Ravenna North

2nd Recommendation Meeting / Design Review
2101 NE 88th St
DPD #3023106

NICHOLSON KOVALCHICK ARCHITECTS

OLD ENTRY COURT LAYOUT PRESENTED AT DR1

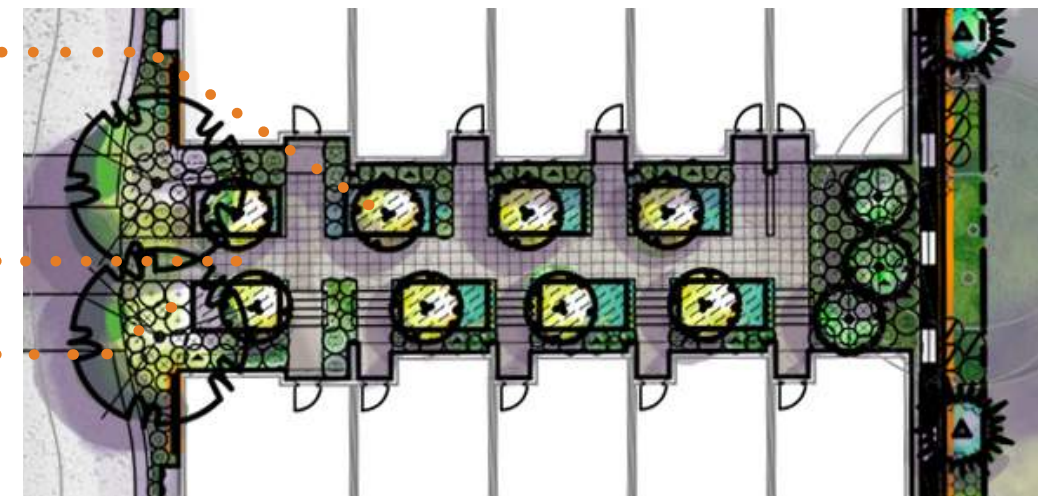
- (DR1) Due to the size of the site, a greater distinction of open space was expected. The Board agreed the open space program was not compelling and lacked hierarchy. To instill a sense of hierarchy, consolidating the open space into a larger area was suggested. (DC3-B)

As at the Initial DR Meeting, Entry Courts are provided where units face on another. These landscaped areas are designed to be used and occupied, but not as heavily as the Primary Green Spaces. As the site plan was refined after DR1, these Entry Courts got 30% wider, providing between 8' and 11' more separation between buildings. At-grade bioretention facilities are large enough for deciduous trees and other plantings, while still allowing for individual planters at each unit entry way which help to identify and distinguish each unit.

Lastly, although the overall concept of each Entry Court is the same, unique identifiers are planned at the point of entry for each court. These elements include a rock feature, a pergola, reclaimed wood, and unique tree specimens.

NEW RENDERED SITE PLAN AT URBAN FOREST

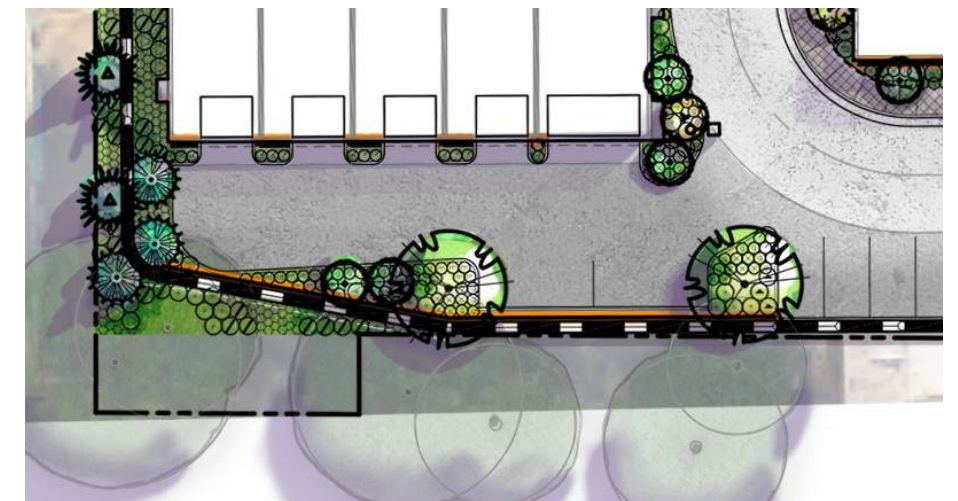
- (DR1) Due to the size of the site, a greater distinction of open space was expected. The Board agreed the open space program was not compelling and lacked hierarchy. To instill a sense of hierarchy, consolidating the open space into a larger area was suggested. (DC3-B)

Tree selection and location has been carefully considered by the design team. During the first Recommendation meeting, the Board asked evergreen trees be used sparingly or not at all in areas intended for active use. In the Primary and Secondary Green Spaces, deciduous and small evergreen trees are used, so that people recognize these spaces as inviting. In the Tertiary Green Spaces, the project utilizes evergreen trees in order to provide landscape buffers and to create "urban forest" areas. These are not intended to be actively used, but to create lush landscaping at the project's edge. In many cases, these infill trees work with existing Exceptional perimeter trees and groves. They also provide privacy, both for this project and its neighbors.

NEW TYPICAL MOTOR COURT - RENDERING

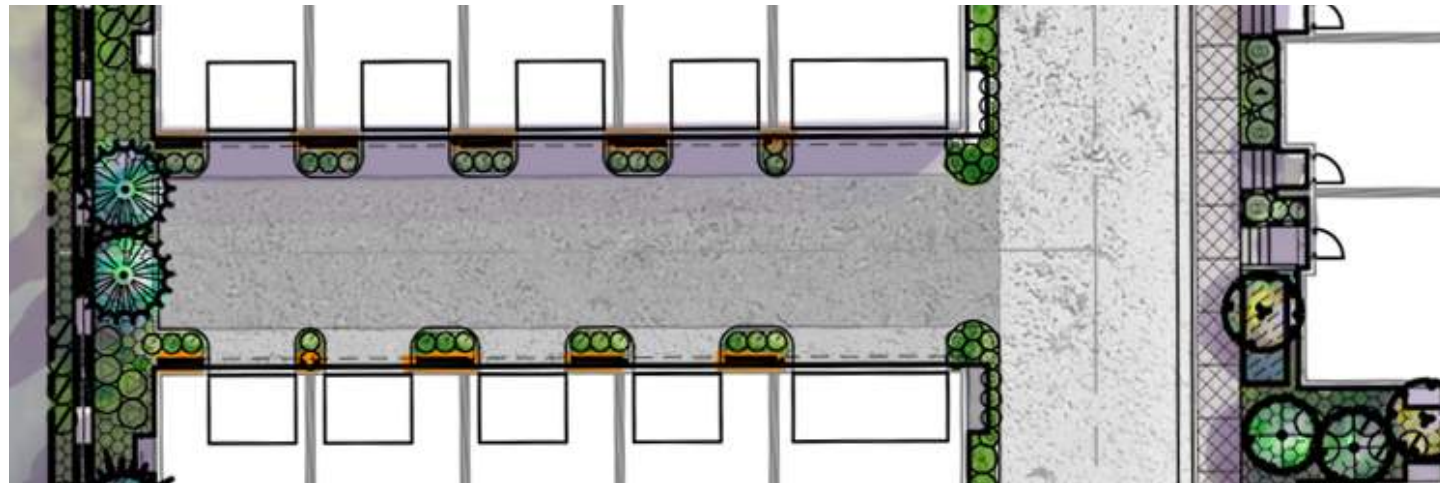
- (DR1) The Board agreed there is an opportunity for the auto courts to be designed such that they are viewed as back patios for the residents, and recommended further development of these areas. The introduction of planters, trees, and variety of hardscape patterns was suggested. (DC3-B)

In order to ensure that the motor courts function as residential back patios, several changes were made from the initial DR Meeting. Primarily, a scored concrete pattern will be used to signal to drivers that this space is shared between people and cars. Juliette balconies facing down into the motor courts were added to the interior units in order to provide more interaction between interior and exterior space. Additional upper level glazing was added to provide additional eyes on these areas. Glazing was added to the garage doors. Larger planters break up the expanse of paving and introduce small trees into these areas. Garage doors can be opened up allow activity to spill outside and further increase the sense that these spaces act as "back patios" for the residents.

NEW FRONT ELEVATION (BUILDING P SHOWN)

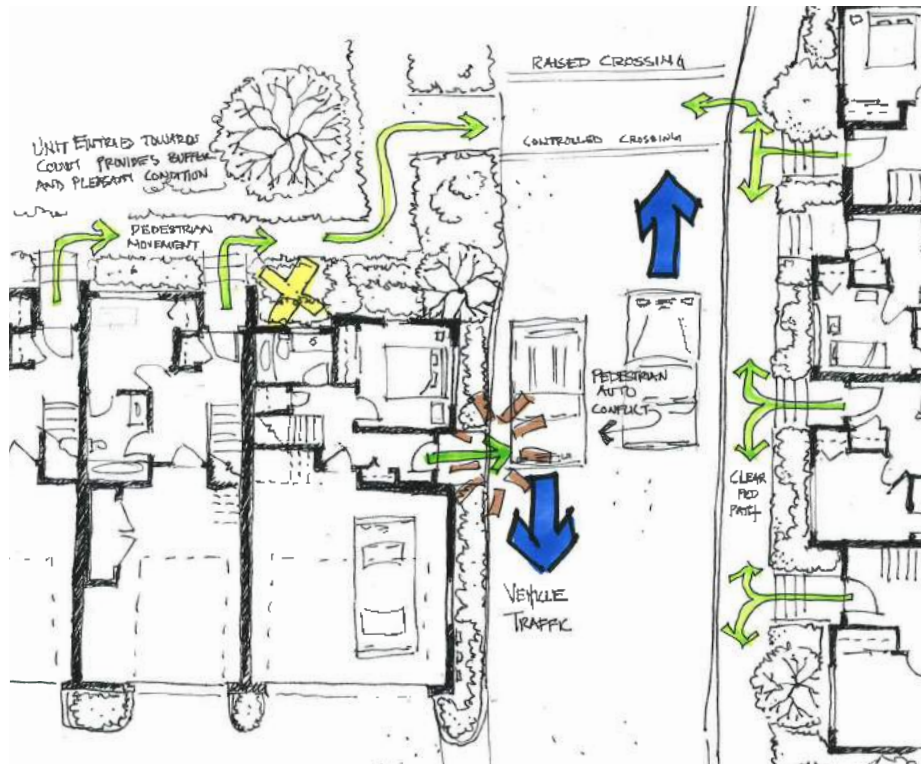
- The Board directed further exploration of the townhouse typology and introduction of elements and design solutions to enhance the individual character of each unit. (DC2-B)
- The second and third floors lack cohesion while the ground level reads as a large plinth of cement siding. (DC2-B)
- The Board noted that the siding and the roof forms appear very independent, leaving much opportunity for the siding to engage the roof. A stronger dialogue between the siding and roof form is needed. (DC2-B)

Strengthening the Townhouse Typology lead to key changes to the building elevations. Shed roofs were added to each building in order to delineate individual units. As requested by the Board, the roof forms work with the siding and accent locations. Additional information on the variety of shed rooflines can be found on the following pages.

The vertical fin walls used in the first DR designed were retained. These were used to reinforce the material and color accents which now extend down to the second level and increase cohesion between floor levels. About half of the units have small unit entry stoops. Buildings A & B have bolt-on decks oriented to the interior of the site, while the other units have large second level decks along the front elevation.

RENDERING - SIDE ELEVATION AND MOTOR COURT

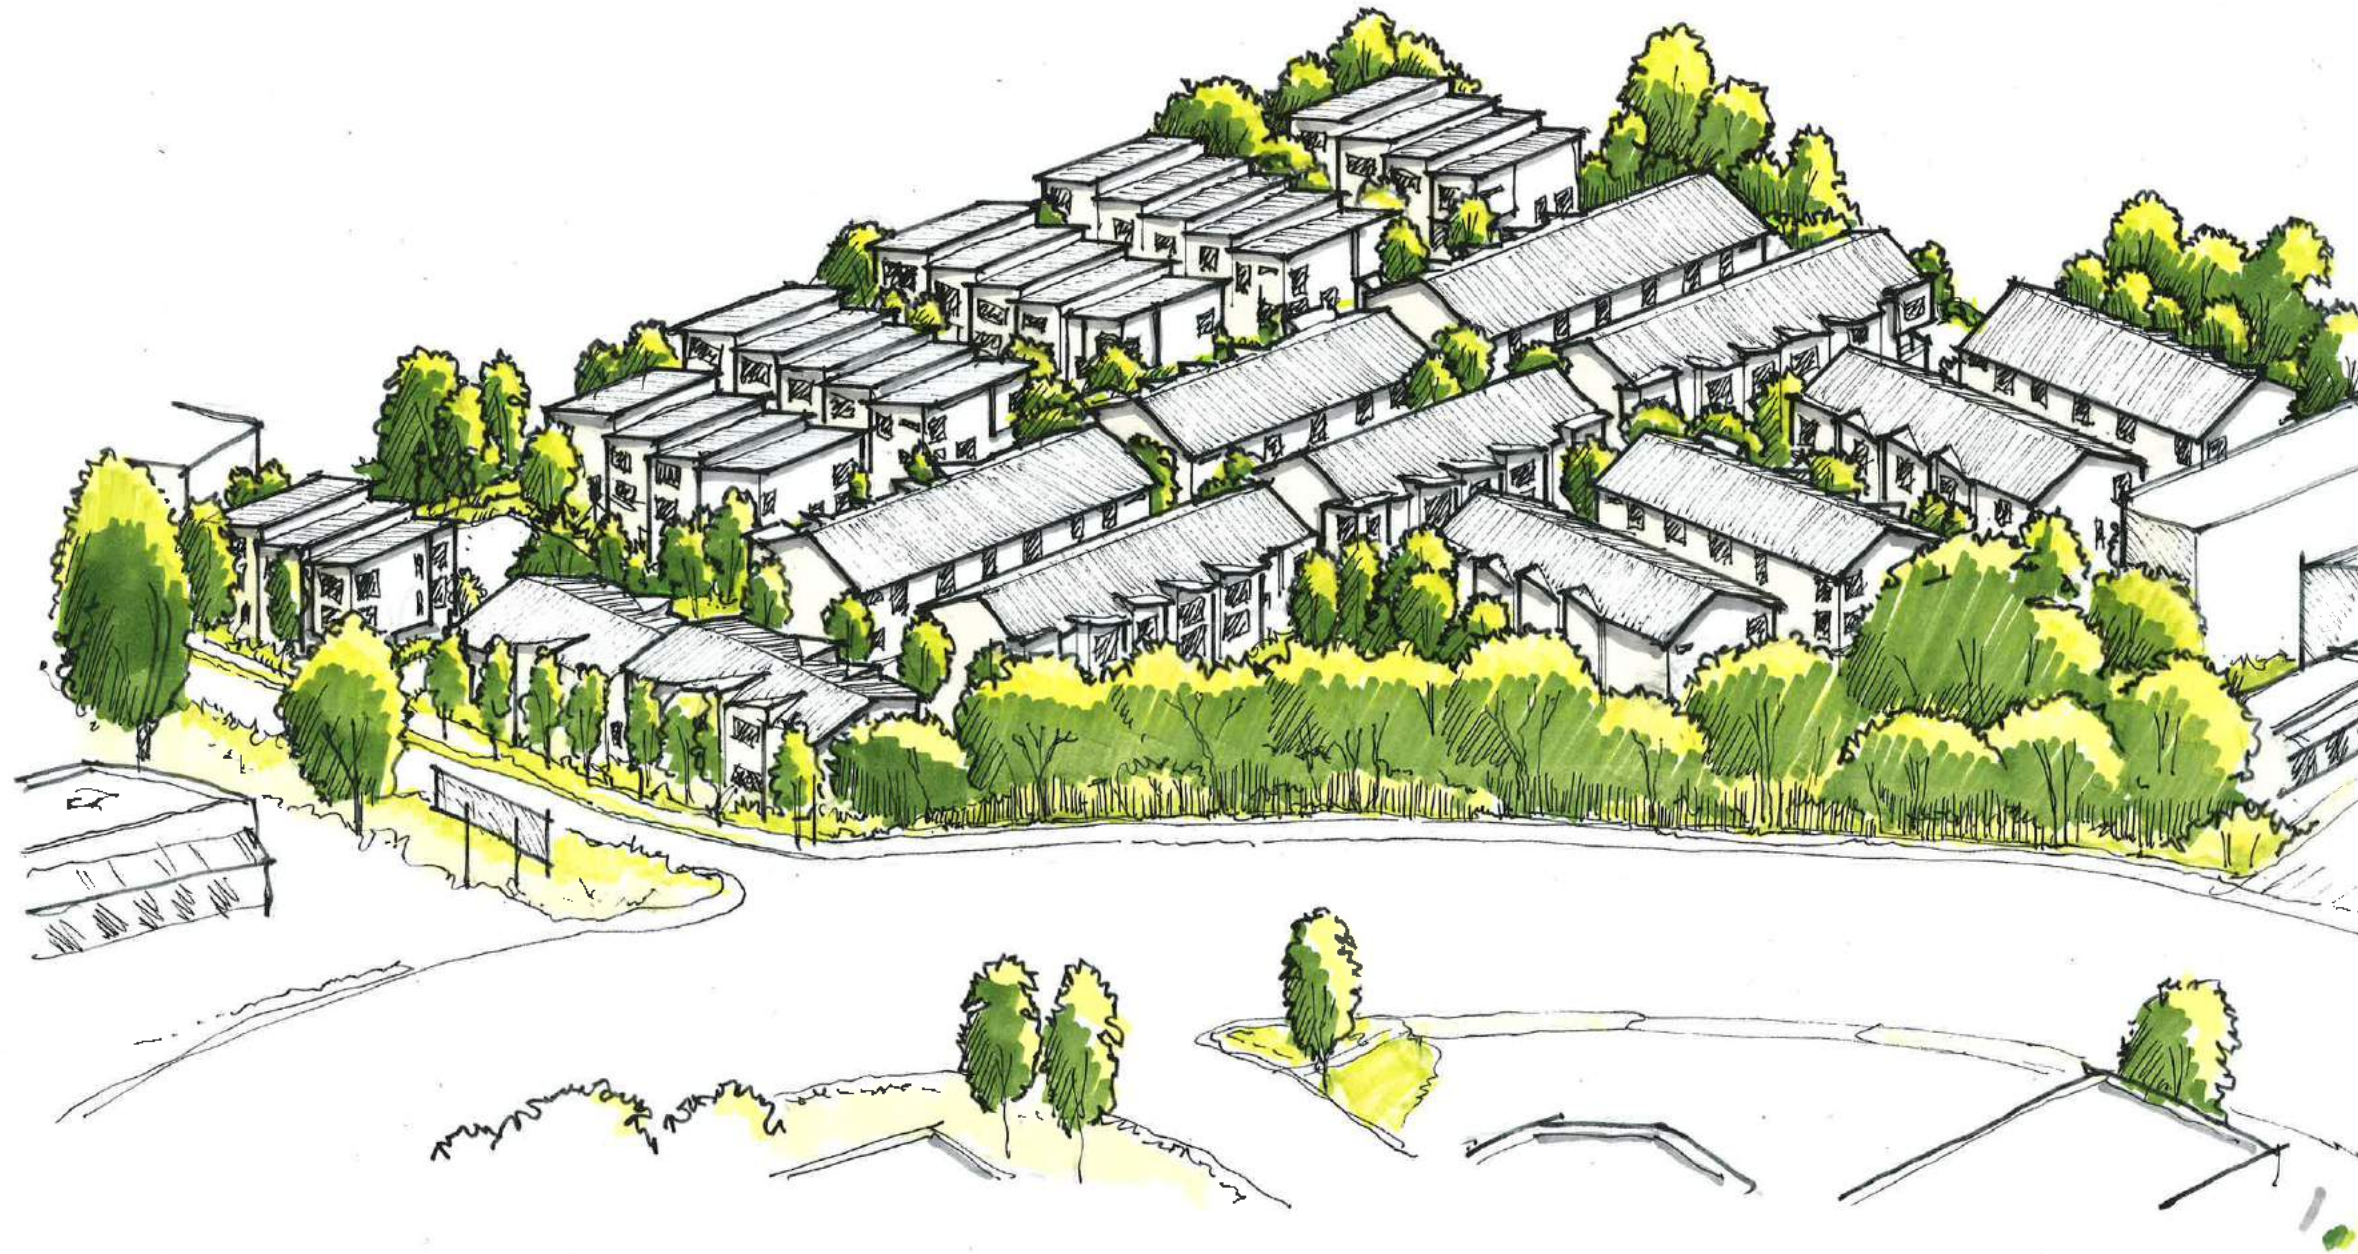
- (DR1) The Board recommended the introduction of windows and plantings to mitigate the blank wall condition while respecting safety and security concerns of the unit residents. (DC2-B)
- (DR1) The Board noted that the change in materials and color application is not easily understandable. The Board suggested using reveal patterns and detailing to articulate changes in material. A change in material without a change in plane is not supported. (DC2-B)

At the direction of the board, the team explored how to create more active side elevations for the perimeter units that face the drive aisle. At Level 1, an additional high window was added in the garage. A larger bedroom window was considered, but it was concluded a larger bedroom window would be more likely have the shades constantly drawn for privacy, limiting the benefit of the new window. Therefore, the project is proposing a high window.

Additional building modulation is now proposed by inseting the Level 1 wall at the garage. This allows for shadow lines as well as increasing the width of the planter. Since the central sidewalk is generally not adjacent to the perimeter buildings, these walls are generally experienced from across the drive aisle. Because of this, more of the upper levels are visible and the wrap around deck, glazing, and upper level building modulation also contributes to the experience of these facades.

Another option we explored was facing the front door of the end unit towards the drive aisle. This scheme had several cons. From a resident perspective, it meant losing the gracious entry facing out on to the landscaped entry court. From a safety perspective, it meant pedestrian leaving the building at a point without an adjacent sidewalk or a raised crossing. In addition, it meant that we'd lose the vertical connection from the fin wall adjacent to the door up to the shed roof.

BUILDING SEPARATION AT LEVEL 3 IN ENTRY COURTS, TYP

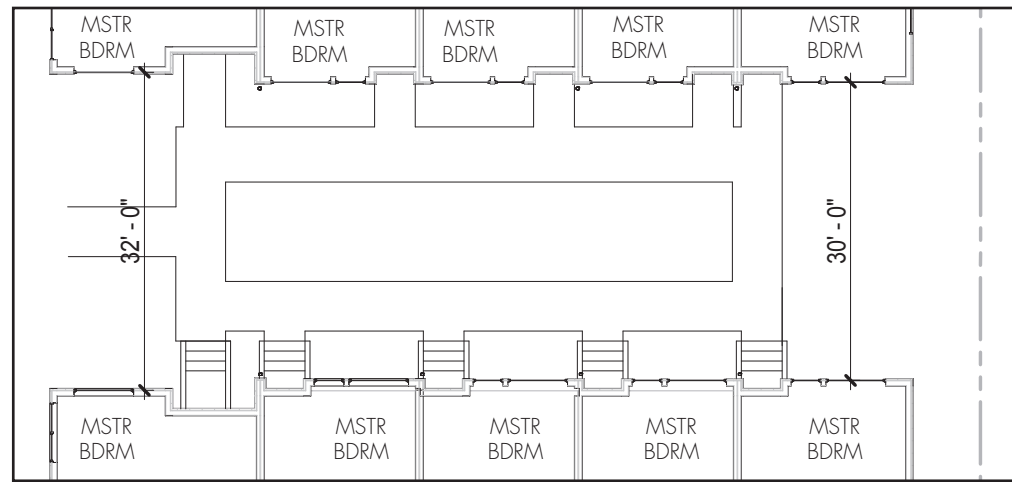
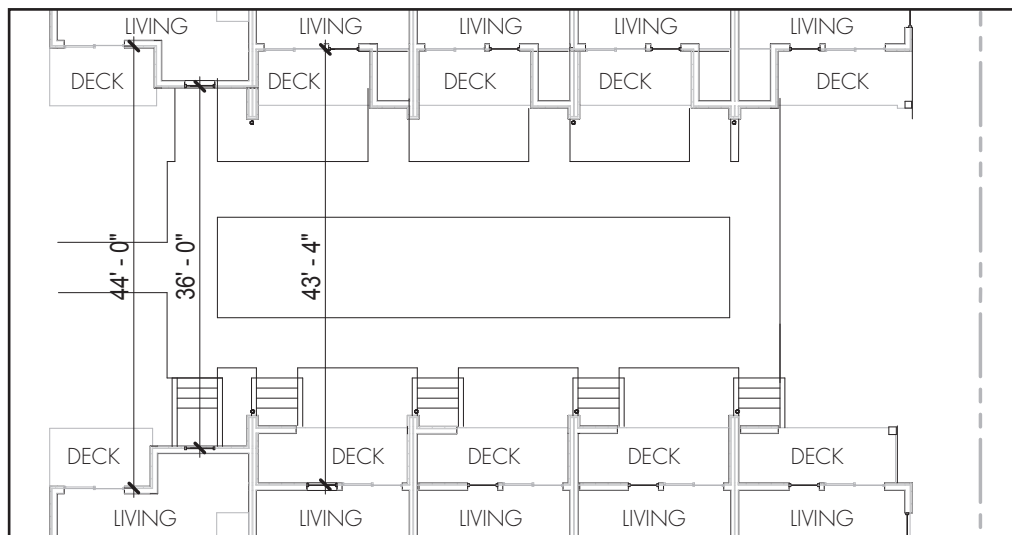
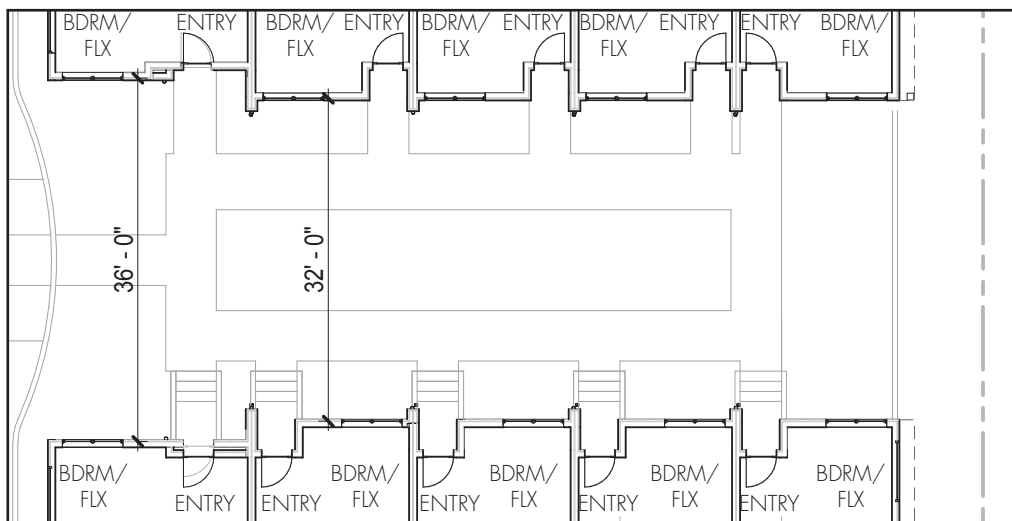
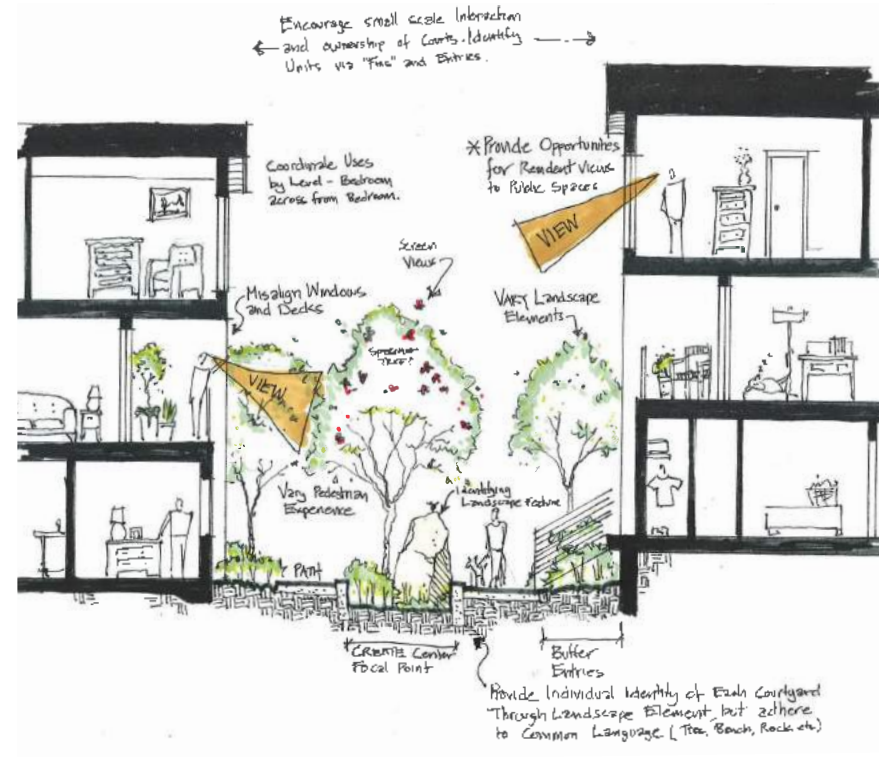
As requested, typical privacy floor plans and a diagram has been provided.

There is some overlap between glazing in units that face each other across the Entry Courts. This is mitigated by several circumstances. First, these facades are at a minimum 30' apart, which is 27-34% more building separation over the layout proposed at DR1. Second, due to the grading of the site, units that face each other are not at the same finish floor level and this difference means that the eye level of the units are not directly across from each other.

At different levels, there are additional considerations. Interior unit plans were deliberately mirrored so that front doors are offset where possible and planting provides some screening for the first and second levels. In addition, the Level 2 deck means that the interior of the unit is further recessed.

DESIGN DEVELOPMENT CONSIDERATION - WOONERF PRINCIPLES

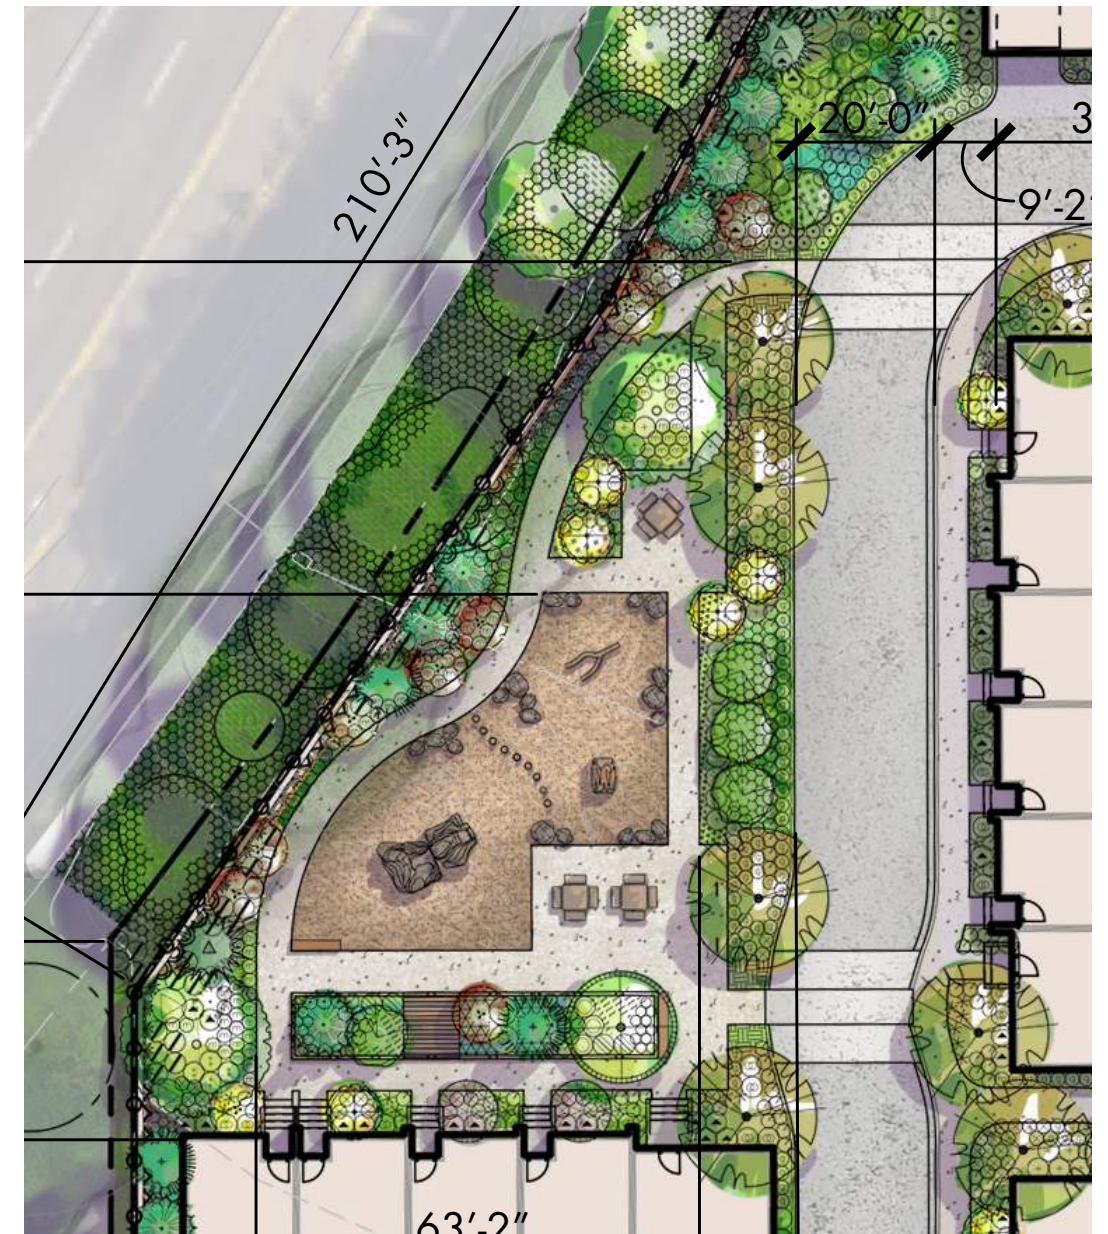
At the suggestion of the Land Use Planner, a design that uses woonerf principles was considered for the Community Gathering Area. This would result in a significant reduction in planting area, and increased safety concerns. The team felt it was unwise to blur the distinction between road and pedestrian space in an area intended for children. The final design proposal results in a heavily landscaped, tree-lined street, with designated pedestrian crossings and a clear delineation between car and pedestrian traffic.

- COLOR DISTINCTION BETWEEN "ROAD" AND "SIDEWALK"
- PLANTERS
- NO SEPARATION BETWEEN FRONT DOOR AND ROAD, UNSAFE FOR HOMEOWNERS
- NO SEPARATION BETWEEN PLAY AREA AND ROAD, UNSAFE FOR CHILDREN AT PLAY
- REDUCED VEGETATION BUFFER BETWEEN UNITS AND ROAD
